AGENDA ITEM SUMMARY REPORT

APPLICATION NO.: Sign Permit (SA 6-16)

REQUEST: Replace a damaged nonconforming 17-foot tall, 42 sf freestanding sign with: 1) a new nonconforming 14-foot tall, 30 sf freestanding sign; 2) 9.8 square feet of wall signs; and 3) 34 square feet of LED lighting. The project would also require the removal of 24 square feet of existing wall signs.

LOCATION: 863 North Main Street

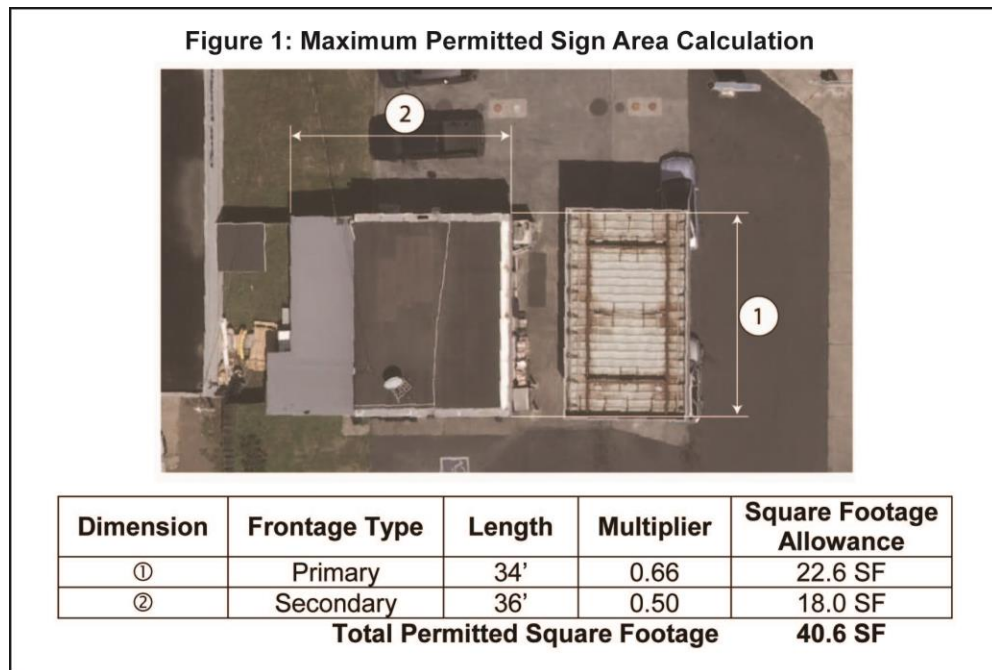
Table 3-12 of the CLUDC outlines sign standards and allows maximum sign areas based on building frontage. The subject building has 34 linear feet of primary frontage on Main Street, and 36 linear feet of secondary frontage on Elm Street, permitting a maximum of 40.6 square feet of total signage (see **Figure 1**).
